Fwd: Case # 16Zone1056

I would like the following comments be considered and added to the record regarding the Prospect Cove Development at Timber Ridge Dr. and River Road in the Prospect area.

As an interested party, I would like to provide a number of remarks concerning the Planning Commission Staff Report dated January 31, 2017, regarding Case No: 16zone1056, the 198 unit senior housing facility named Prospect Cove. In particular, the comments under "STAFF ANALYSIS FOR REZONING AND FORM DISTRICT CHANGES

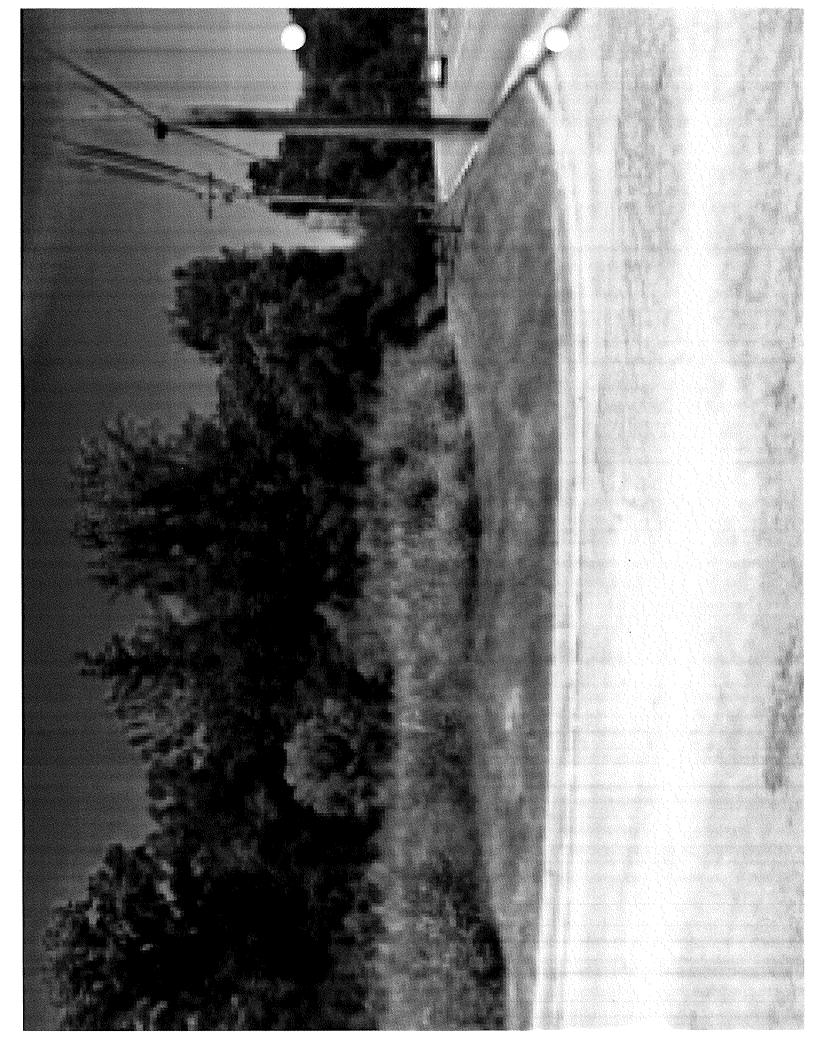
1 B.4 . There are no high density residential units within 2 to 3 miles of the site. The area has single family homes low density condominiums, and low density commercial. The Smithfield Greene condominiums located directly across Timber Ridge rd has 28 units located on about 9 acres which is comparable footprint to the Prospect Cove 198 units. This fact is readily apparent in your aerial photograph.

DLG told us their proposal has 178 two bedroom units, 20 one bedroom units and there could be two people to each bedroom plus any caretaker. The math of that legal requirement (178x4 + 20x2) is 752 residents plus any caretakers. DLG has said the Prospect Mayor exaggerated the population capacity with the 752 residents. That's DGL's stated legal capacity number and not the Mayor of Prospect's. Let's give DLG the benefit of the doubt that they won't achieve 1005 capacity but only 80%. That's 601 residences. 70% capacity is 526 residences.

3 B4 . You state the proposal is located "outside of the village form". That is not accurate. The proposed development and the City of Prospect share a common property line along Timber Ridge road from River road to Prospect Cove. See Attached picture. Prospect cuts the grass west of Timber Ridge between River road and Prospect Cove. The owner of the proposed site has not in this photo..
